**Rezoning Transportation Analysis**  
**Petition Number: Insert Zoning Petition #2021-209**  
*General Location Identifier: 20109103*

Revision Log:	Date	Description
	01-24-2022	First Review (KP)
	03-21-2022	Second Review (KP)

# Rezoning Transportation Analysis

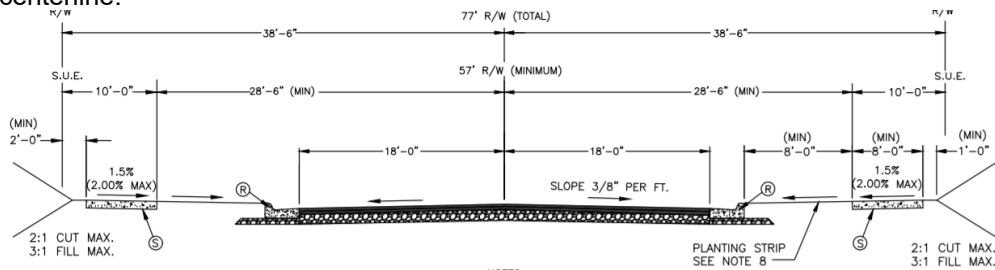
Label and dimension the back of curb and gutter from the existing centerline of each road.

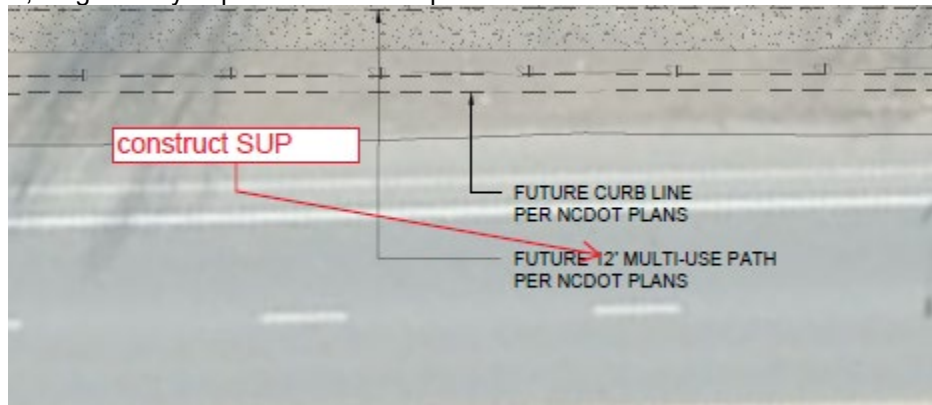
- a. **Steele Creek Road:** Revise site plan and conditional note(s) to commit to dedicate the right-of-way and easements, in accordance with the typical section established in the U-5766 STIP Project, as generally depicted as on the site plan.

- b. **Rigsby Road:** Revise the site plan and conditional notes to dedicate 38.5 feet of right-of-way, in accordance with CLDSM U-05A Local Commercial Wide cross section, from the existing road centerline.

**Outstanding Comment:** The site plan shall label and dimension the right-of-way from each road centerline.

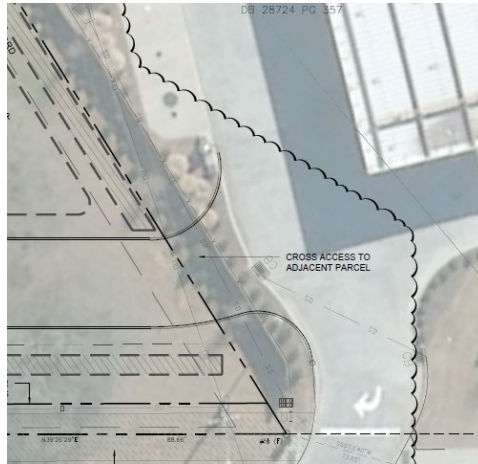
9. A site plan note(s) specifying dedication and fee simple conveyance of all rights-of-way to the City and NCDOT before the site's building certificate of occupancy is issued as needed. CDOT requests rights-of-way set at 2' behind back of sidewalk where feasible.

**Update to Comment as a Result of 03-14-2022 Site Plan:** Place a sidewalk utility easement 2-feet behind the sidewalk along Rigsby Road.

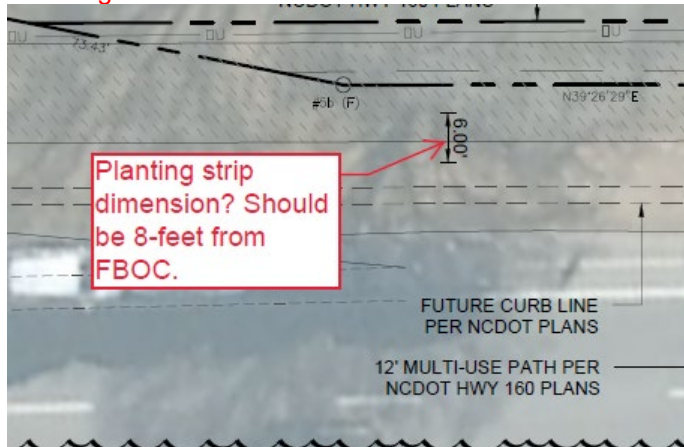
- 12. **New Comment as a Result of 03-14-2022 Site Plan:** Revise the conditional notes by committing to provide an access easement, during permitting, with PID 20109114 to allow cross-access as generally shown on the site plan.

- 13. **New Comment as a Result of 03-14-2022 Site Plan:** Revise the site plan by clarifying the 6-foot dimension on the site's frontage of Steele Creek Road.
